U.S. Department  
of Transportation  
**Federal Highway  
Administration**

In Reply Refer To:  
HSST/ WZ-308

This is in response to your June 1, 2011, correspondence requesting the Federal Highway Administration's (FHWA) acceptance of your company's DSB100W Portable Sign Stand as a crashworthy traffic control device for use in work zones and elsewhere on the National Highway System. Accompanying your letter was the FHWA Office of Safety Design form and drawings of the stand. You requested that we find this device acceptable for use on the NHS under the provisions of National Cooperative Highway Research Program Report 350 "Recommended Procedures for the Safety Performance Evaluation of Highway Features."

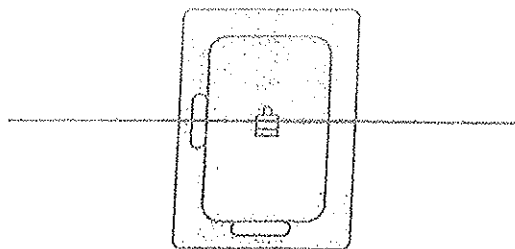
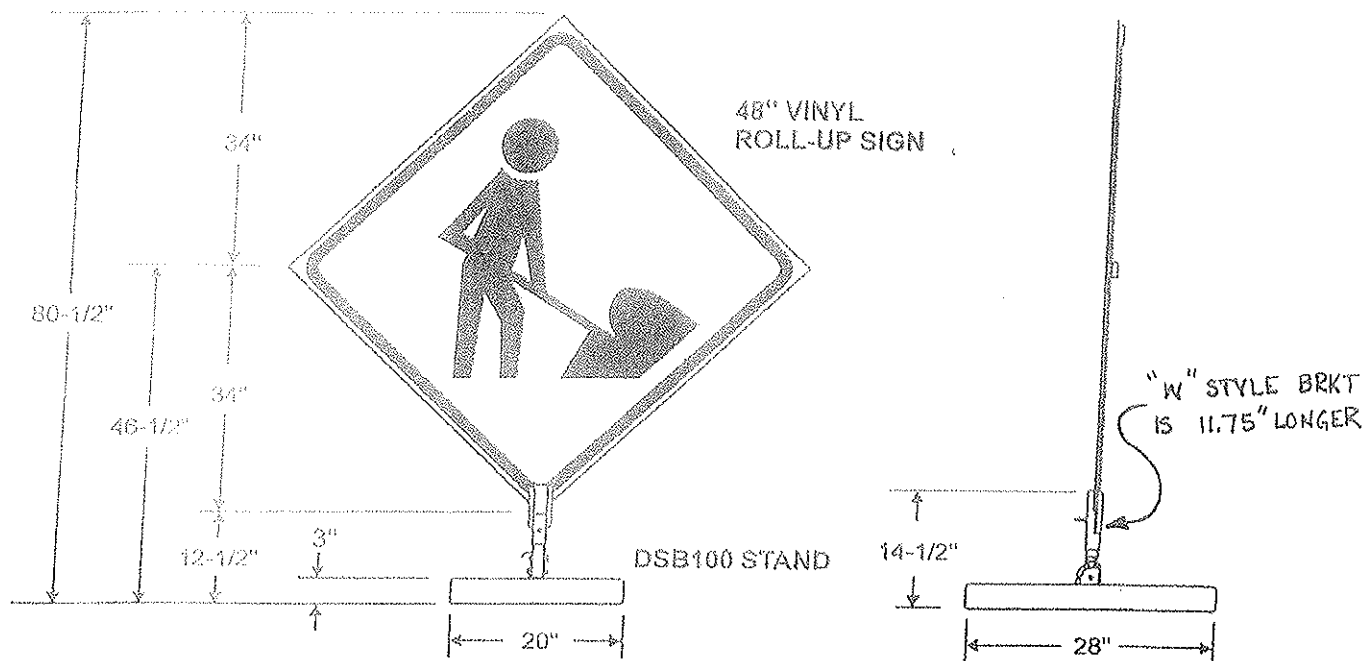
Based on the enclosed information and previous test data, we are seeking acceptance of sign stand DSB100W. We believe this to be a reasonable request because the only difference between this and the already accepted DSB100 is the height of the sign bracket. The height of the "W" bracket is below the windshield impact zone and falls within the range of previously accepted stands. Therefore, we believe it is fair to assume that this stand configuration will perform as well as the original. As such, we contend that there will be no effect on the windshield impact data.

This letter is the acknowledgement of the FHWA's acceptance of your request and includes the original completed form, your June 1 letter explaining your request, and drawings of the relevant sign stands.
